**HISTORIC PRESERVATION COMMISSION STAFF REPORT**

<b>Address:</b>	5606 York Lane, Bethesda	<b>Meeting Date:</b>	01/11/17
<b>Applicant:</b>	Robert and Ginger Essink	<b>Report Date:</b>	01/04/17
<b>Resource:</b>	Contributing Resource <b>Greenwich Forest Historic District</b>	<b>Public Notice:</b>	12/28/16
<b>Review:</b>	HAWP	<b>Tax Credit:</b>	n/a
<b>Case Number:</b>	35/165-17A	<b>Staff:</b>	Dan Bruechert

**PROPOSAL:** Addition and other alterations

**WEST ELEVATION**  
 SCALE 1/8" = 1'-0"

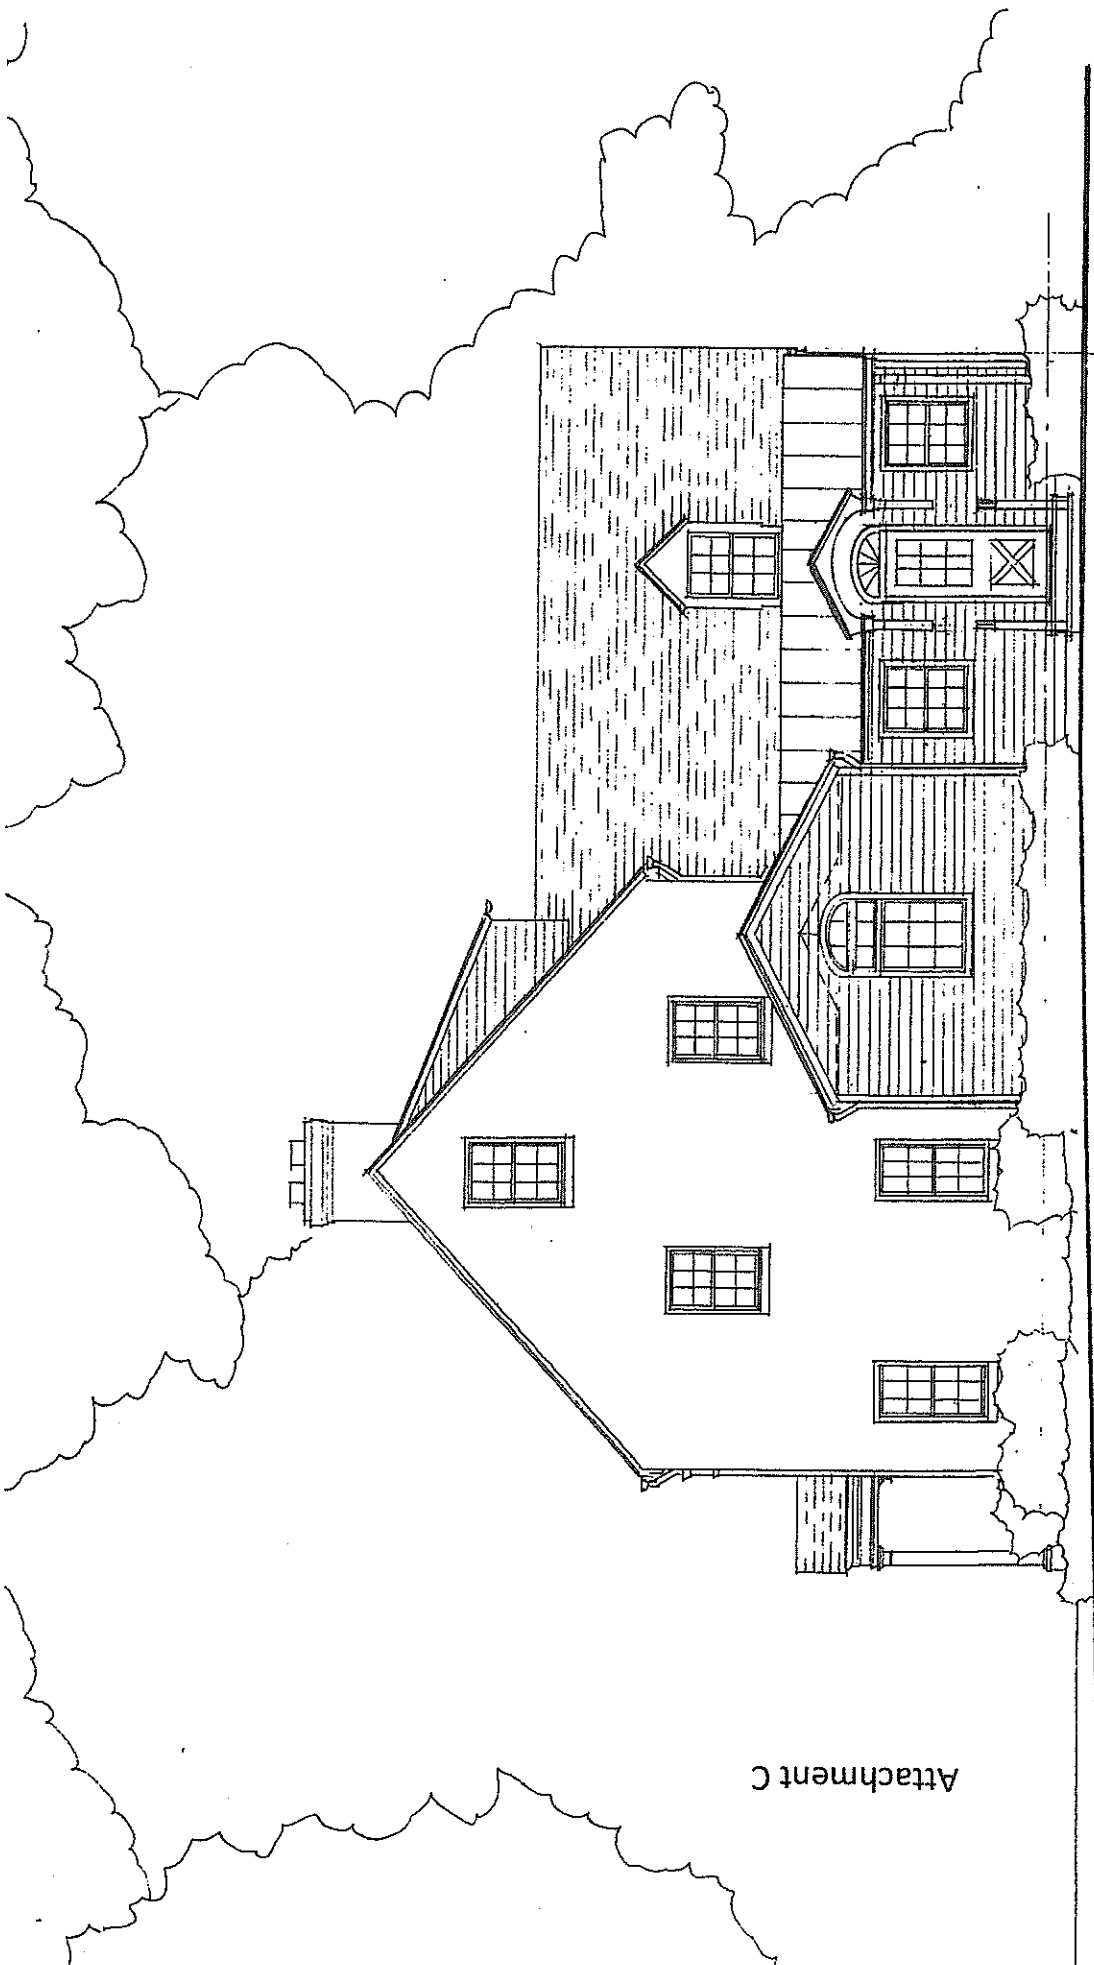
The rear portion of the house's western wall will be demolished to accommodate a one-story expansion of the kitchen and a new wall that will project six feet further to the west (the right side of the house when

viewed from the street). The new construction will be clad in Hardiplank siding topped by a side gable roof with slate shingles to match the historic core of the house. The west wall of the new construction will have a contemporary casement window with a nine-light rectangular casement and arched top.

A window is proposed for the west elevation of the addition. This window features a nine-light (three-light by three-light pattern) casement, with a three-light casement above, topped by an arched three-light fan light. While this design is not one that would have been used historically, it is in a location that is not visible from the public right of way and, per the Design Guidelines, is to be given only limited scrutiny in its review (Appendix 1A). The arched top of the casement window seems to be taking design cues from the historic fan-light above the front door and is appropriate in this location. The frame details are consistent with the proposed new windows in the rear of the house.

Lastly, the placement of this expansion does shorten the setback to the west by six feet (6'). After construction, the setback to the western property boundary will still be more than seven foot (7') side setback required with a total side setback of approximately thirty-five feet (35'); significantly exceeding the eighteen foot (18') requirement in the Design Guidelines (D5).

The proposed addition at the rear of the house contains a new entry, mud room, and bathroom and will project nine feet (9') to the west from the historic wall plane. It will not be visible from the public right-of-way because of its placement behind proposed kitchen addition; and would only be minimally visible from the public right-of-way because it is at the rear of the west elevation of the house. Because this addition does not face forward, design guidelines dictate that it is to receive moderate scrutiny in its review (Appendix 1A).

Matching the appearance of the kitchen addition, the expanded room at the rear of the house will be clad in Hardi siding. The rear wall the new construction will be inset from the historic brick wall which will further differentiate the new construction from the historic. However, unlike the kitchen roof, the expansion at the rear will have a standing seam metal roof, a material found in other houses in the historic district. The metal will be painted dark gray to blend in with the color of the historic slate roof.

The side entrance to the rear addition includes a pediment supported by two columns and a concrete stoop. The appearance of this pediment is a striped down version of the pediment on the primary façade including the fan-light above the door.
